Access Compliance Report Public Rights-of-Way (Curb Ramps)

Main Street: WINDMILL_AVE Cross Street: SNAPDRAGON_ST Location: N

ADA ID: RPRK211109114604 Ramp Type: Type 1 - Perpendicular Initial Pass/Fail: Fail Overall Compliance: No Severity Score: 60

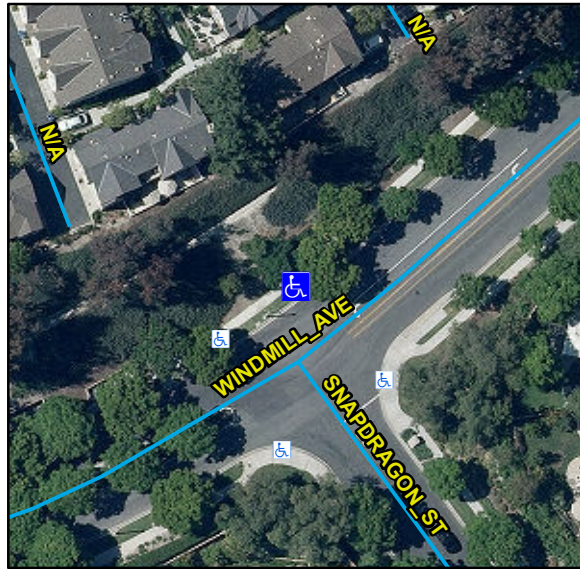
R304.2.2, R204.3, R304.5.3, STD 1115

Compliance	Description	Data	Compliance	Description	Data
N/A	Ramp Length (in)	77	N/A	Flare Type LT	
Yes	Ramp Width (in)	48			N/A
No	Ramp Run Slope (%)	13.2	N/A	Flare Slope LT (%)	N/A
No	Ramp Cross Slope (%)	9.1	N/A	Flare Traversable LT	N/A
N/A	Landing Present	N/A	N/A	Flare Type RT	
N/A	Landing Length (in)	N/A			N/A
N/A	Landing Width (in)	N/A	N/A	Flare Slope RT (%)	N/A
N/A	Landing Run Slope (%)	N/A	N/A	Flare Traversable RT	N/A
N/A	Landing Cross Slope (%)	N/A	N/A	DWS Provided	N/A
N/A	Landing Movement Obstructed?	N/A	N/A	DWS Contrast	N/A
	Landing Movement Type	N/A	N/A	DWS Length (in)	N/A
N/A	Landing Shared	N/A	N/A	DWS Full Width	N/A
N/A	Clear Space	N/A	N/A	DWS Offset Left (in)	N/A
N/A	Clear Space To Crosswalk (in)	N/A	N/A	DWS Offset Right (in)	N/A
N/A	Marked Crosswalk 1	No	N/A	Marked Crosswalk 2	N/A
	Crossing 1 Direction	SE		Crossing 2 Direction	N/A
	Marked Crosswalk 1 Width (in)	N/A		Marked Crosswalk 2 Width (in)	N/A

Remove & Replace Entire Ramp.
